**AN AMENDMENT TO THE
MASTER DRAINAGE DEVELOPMENT PLAN
FOR
WATERVIEW**

WATERVIEW NORTH

EL PASO COUNTY, COLORADO

October 2020

Proposed Pond A

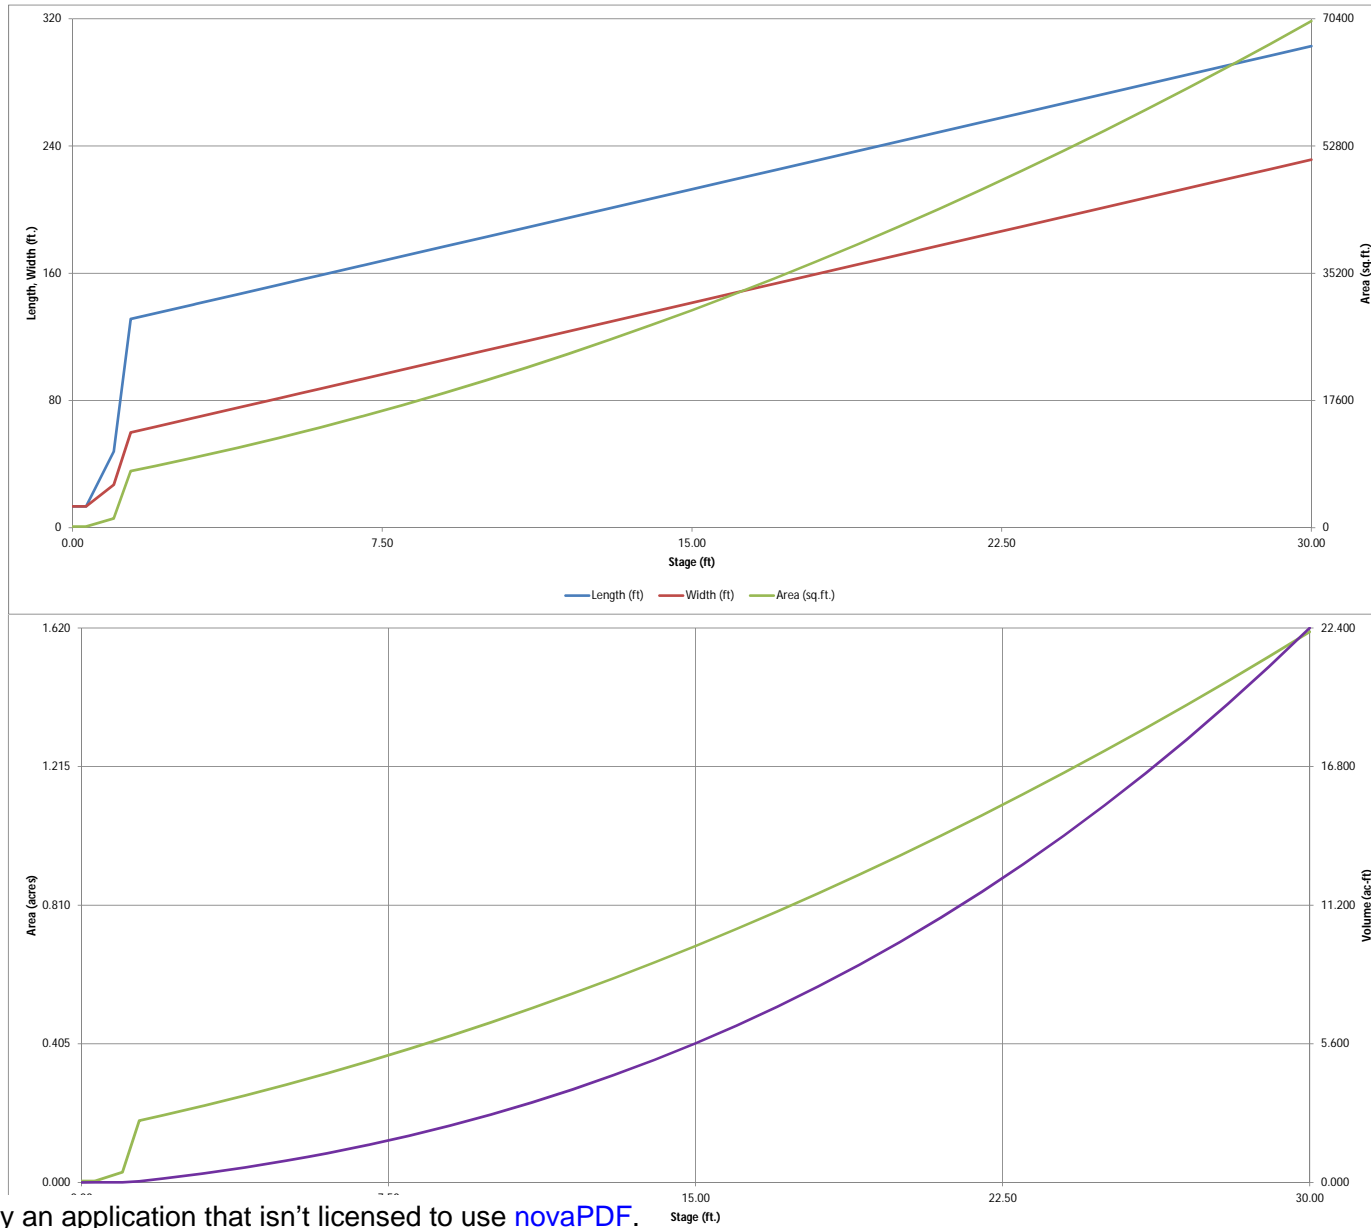
Clarify. The developed drainage map is showing this basin is routed into Pond A. Update Pond A calculation to include basin BJDEV-14 for the pond sizing.

However, if basin BJDEV-14 is supposed to have it's own wq/detention then show the pond on the proposed drainage map and provide the pond calculation. Assuming discharge is as shown on the proposed map then Pond A must be redesigned as a pond in a series.

DSE RESPONSE: The Developed Condition Drainage Plan has been revised. Basin BJDEV-14 is no longer shown as being routed into Pond A. Runoff Generated over Basin BJDEV-14 shall be handled by others and will not be accepted into Pond A.

Total Rating Curve
Crossing: BRADLEY XING DUAL 42 CMP

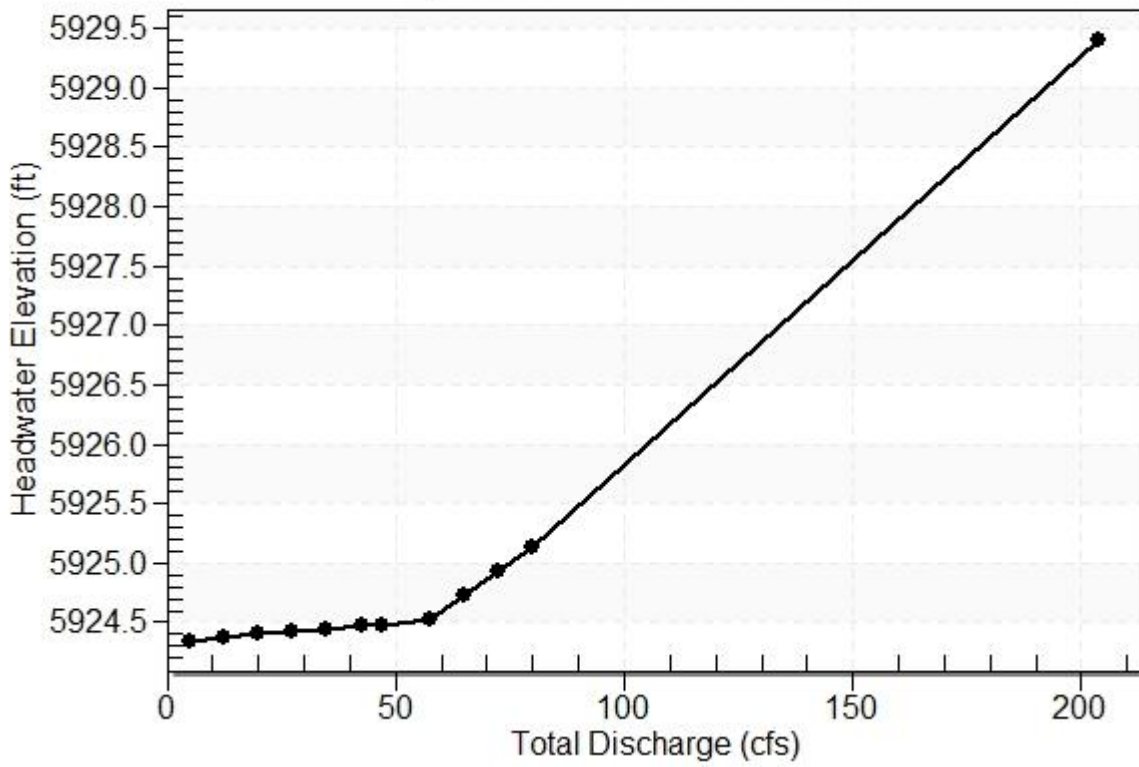
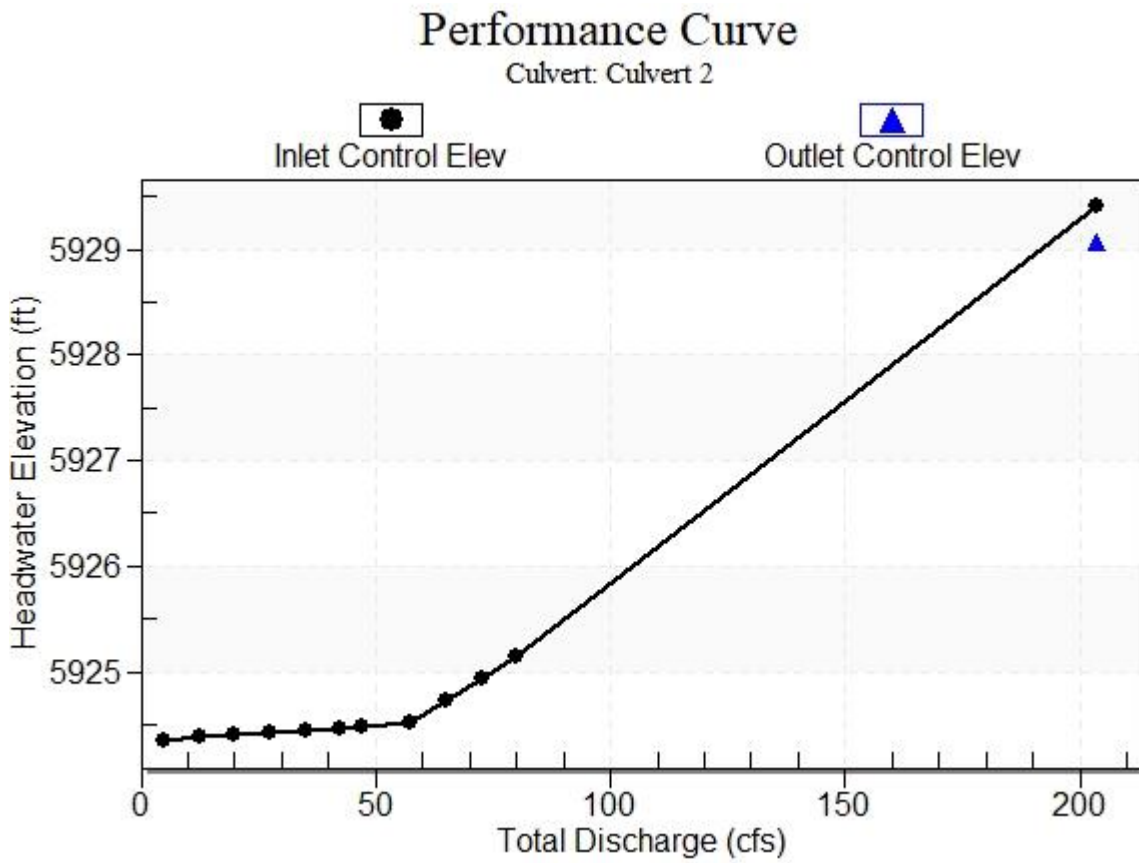
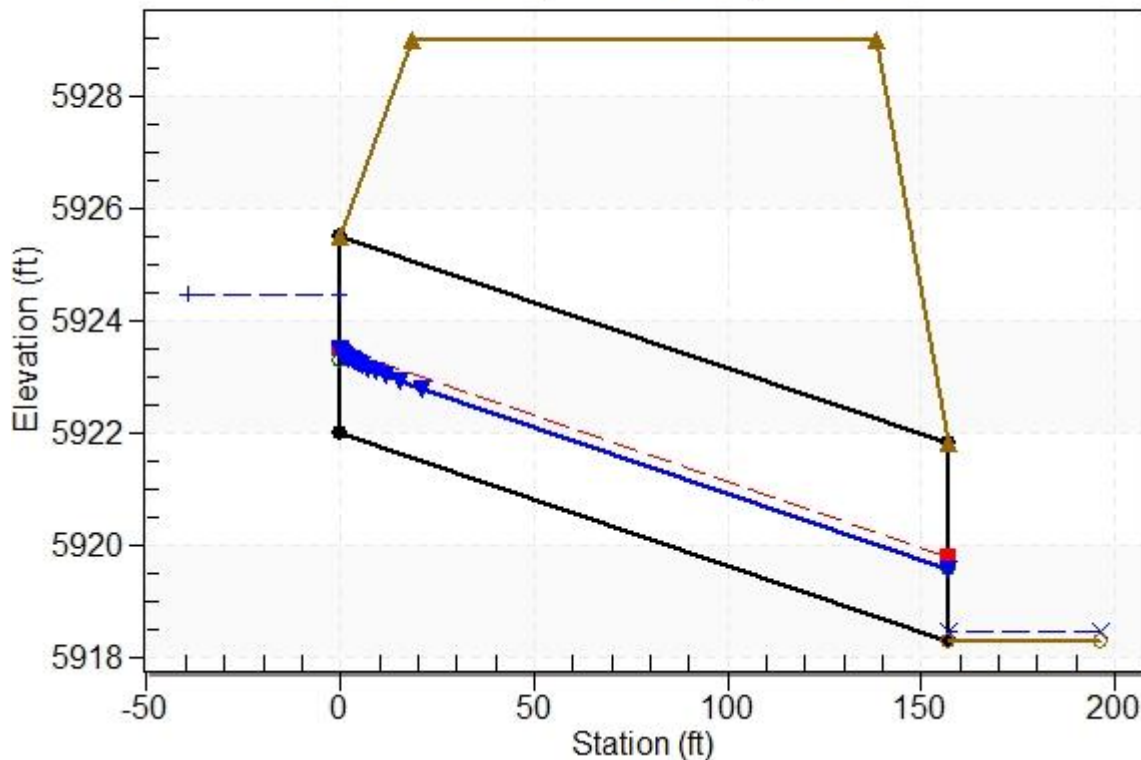
Revise calculation. Per the narrative one is being plugged and the other is reduced.

DSE Response: Post Development Culvert calculations are now included.
